# ***Wenona School***

*State Significant  
Development  
Modification Assessment  
(SSD 6952 MOD 2)*

November 2018

**Figure 3** | Site plan of proposed substation (Source: SSD 6952 MOD 2 2018)

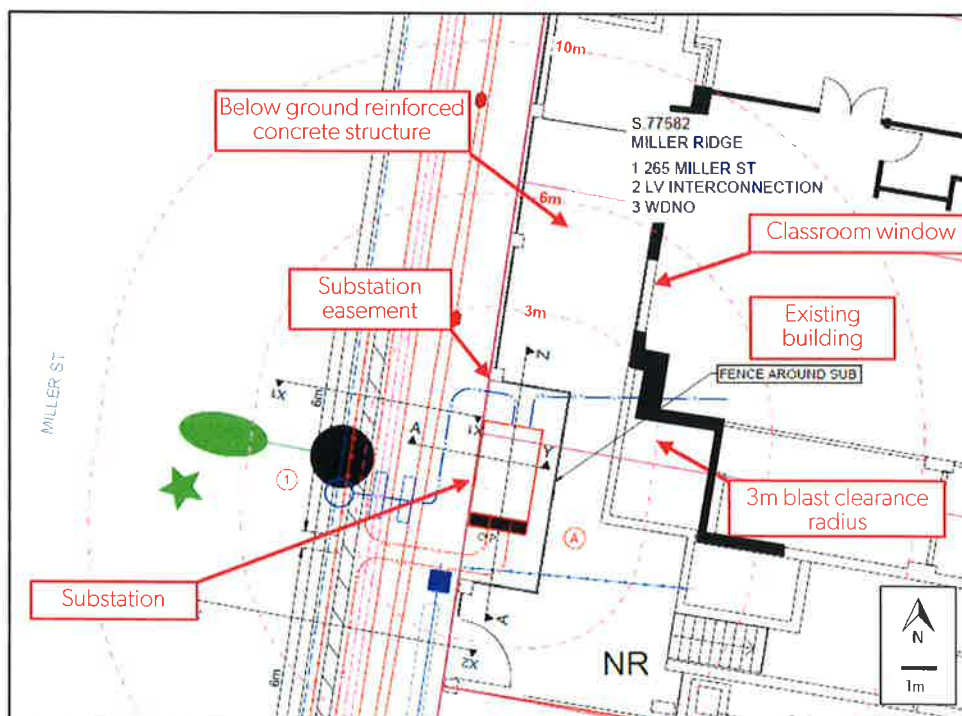
The proposed modification seeks to relocate the substation approximately 0.6 metres to the south, to relocate the substation outside of the existing below ground reinforced concrete structure and have the existing classroom window located outside of the blast distance. The proposed position of the substation is shown in **Figure 3**.

**Figure 4** | Detail plan (Source: SSD 6952 MOD 2 2018)

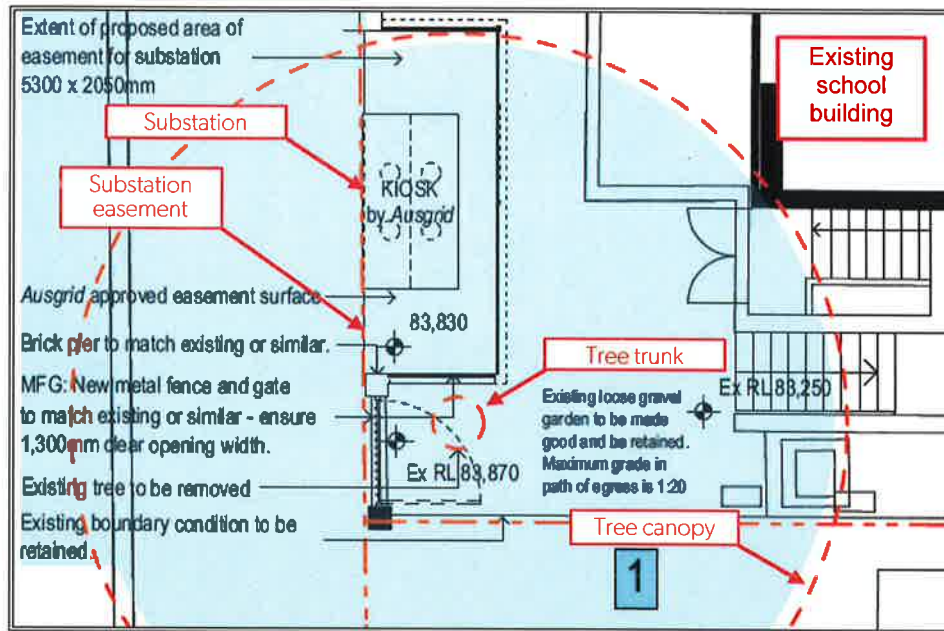
The relocation of the substation places it within 0.3 metres of the Brush Box tree adjacent to the southern boundary of the site. Ausgrid specifications require the tree to be removed because of the proximity of the tree to the substation and surrounding easement. The location of the substation in relation to the tree is shown in **Figures 3** and **4**. The proposed elevation of the proposed substation and fencing is shown in **Figure 5**. A view of the tree from Miller Street is shown in **Figure 6**.

**Figure 7** | Plan showing the proposed location of the subdivision (Source: Applicant 2018)

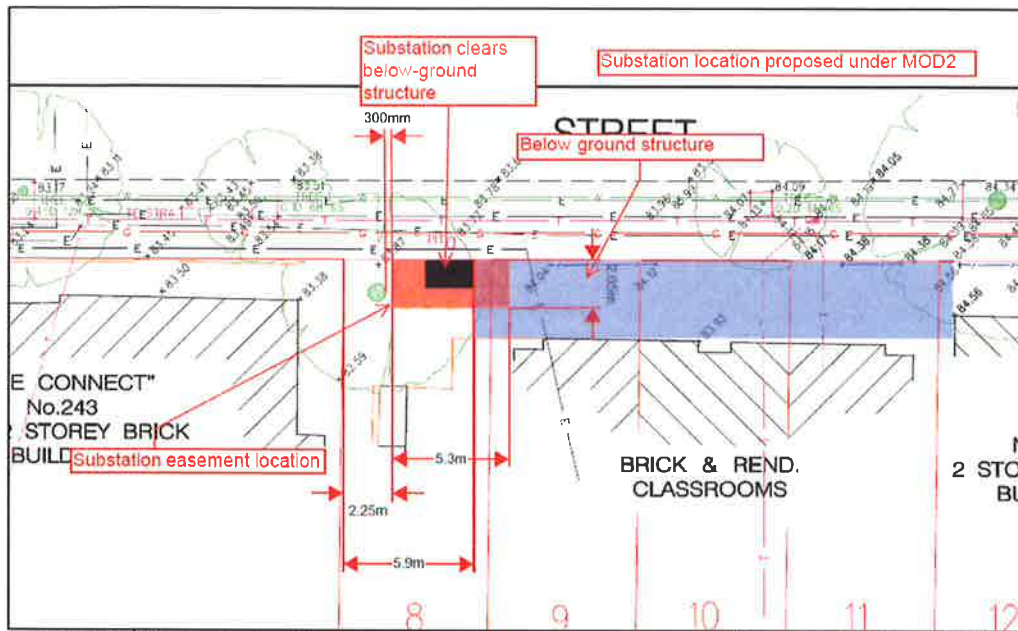
Following the issue of the SSD approval, the detailed design was undertaken and identified the need to locate the substation further to the south than originally proposed in order to meet Ausgrid site design requirements. Specifically, this was required to avoid a below ground reinforced concrete structure forming part of the adjoining school building and existing windows in the building as discussed in **Section 2**.

A plan showing the proposed location of the substation in relation to the below ground reinforced concrete structure is shown in **Figure 7**.
